**NORTHFIELD TOWNSHIP PLANNING COMMISSION
NOTICE OF REGULAR MEETING
May 16, 2018 at 7:00 p.m.
Second Floor, Public Safety Building
8350 Main Street, Whitmore Lake, MI 48189**

We have reviewed the private road application for Jomar Drive submitted by applicant James W. Kugler. This is the second application for Jomar Drive. Our first review is detailed in a letter to the Planning Commission dated January 12, 2017. The proposed private road is about 1,127 feet long, extending east from the cul-de-sac of the existing portion of Jomar Drive. The private road application was also reviewed by the Township Engineer. We have reviewed the private road against the standards of the Zoning Ordinance and offer the following comments:

We have reviewed the plans, revision date December 7, 2017, for the Jomar Park Phase 2 Private Road according to Township guidelines and general engineering standards. A brief description of the project has been provided below, followed by our comments and recommendation.

JOMAR PARK PHASE 2 - PRIVATE ROAD
NORTHFIELD TOWNSHIP, WASHTENAW COUNTY, MICHIGAN
PRIVATE ROAD DESIGN
EXISTING CONDITIONS AND SURVEY PLAN

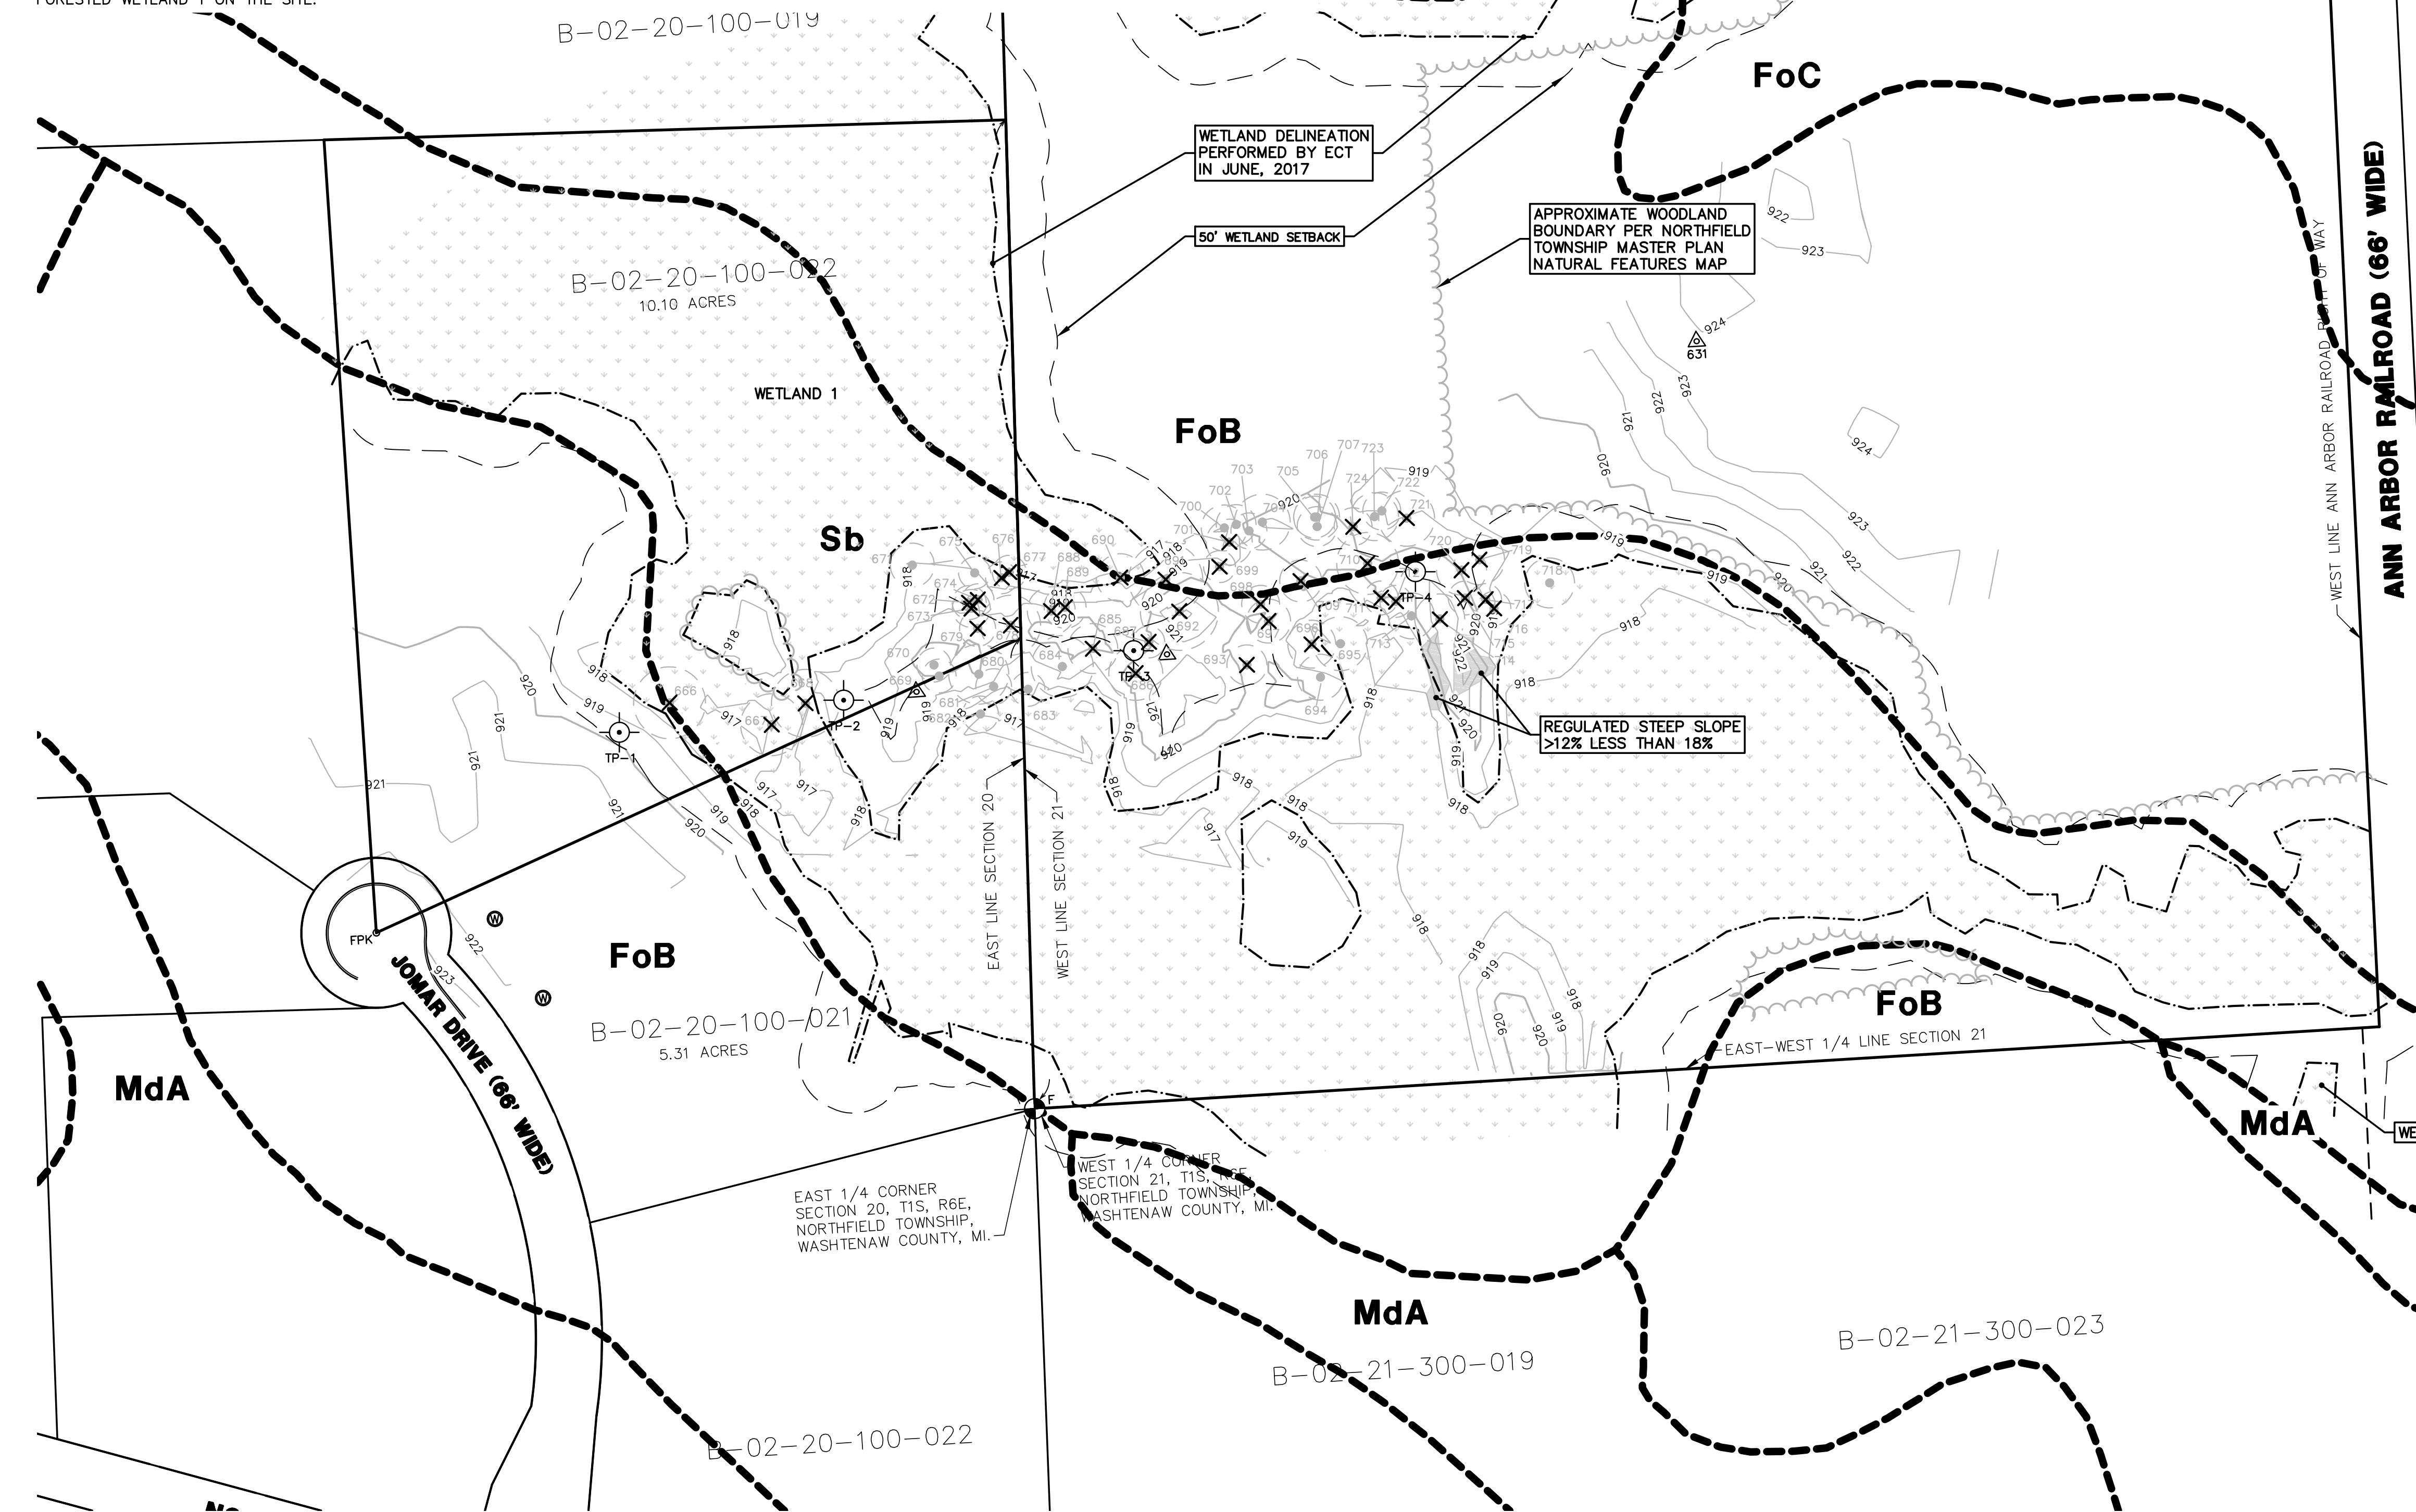
requirements of Section 36-723 would only apply to the site plan or plat applications along Jomar Drive, we recommended more clearly showing the locations of trees to be removed on Sheet 2 of the site plan. This plan shows a table with 58 total landmark trees with 37 to be removed. The proposed mitigation plan shows 33 total trees with 11 deciduous trees with 3" caliper, 4 deciduous with 2.6 inch caliper, and 18 evergreen with 2.5' caliper for a total DBH of 88'. The required DBH replacement value would be 851 DBH. Plan species, location, and schedule is provided. Mitigation is proposed at the time of construction.

We recommend that an additional 4 trees are planted and that the species be Red Oak, White Oak, and White Pine, consistent with the species being removed.

1. An additional 4 trees are planted and that the species be Red Oak, White Oak, and White Pine, consistent with the species being removed.
2. Conditions noted in the engineering review.
3. Receipt of all required permits.
